**Subject:** new paddle switches  
**From:** William F Golisch <golisch@hawaii.edu>  
**Date:** Fri, 23 May 2008 23:36:32 -1000  
**To:** denault@ifa.hawaii.edu  
**CC:** tokunaga@ifa.hawaii.edu

New guide paddle switches required after discussion and agreement among all operators:

<b>newpaddleNOW.jpg</b>	<b>Content-Type:</b> image/jpeg <b>Content-Encoding:</b> base64
-------------------------	--

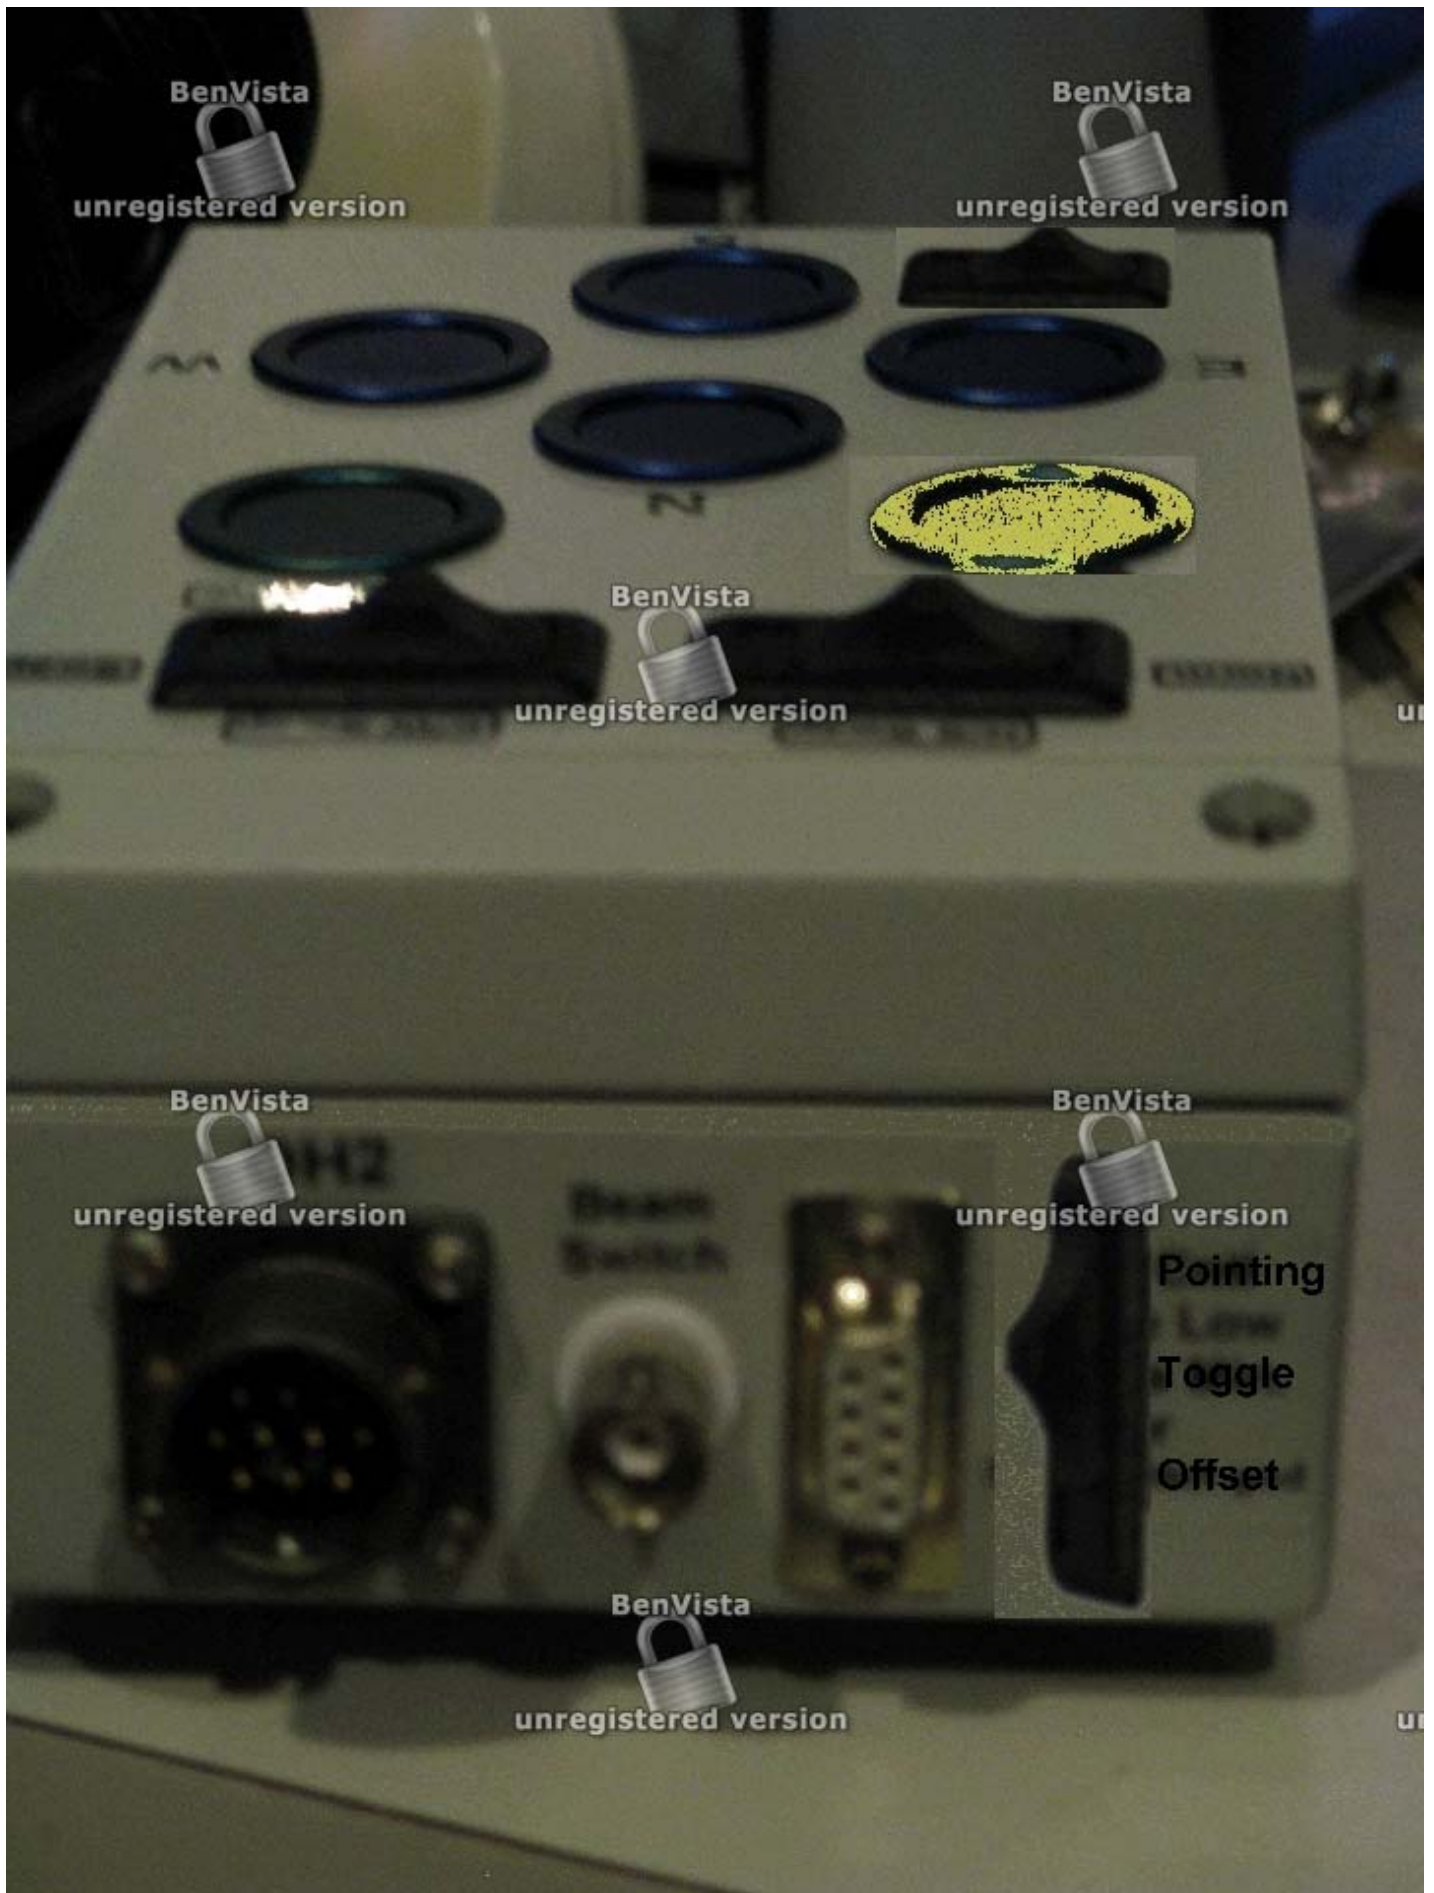
Add toggle on side to switch between pointing and offset motions.  
Add push button for toggling back and forth to base.  
Add toggle to switch in 5 X faster paddle rates.

See attached images for before and after images of changes to paddles.
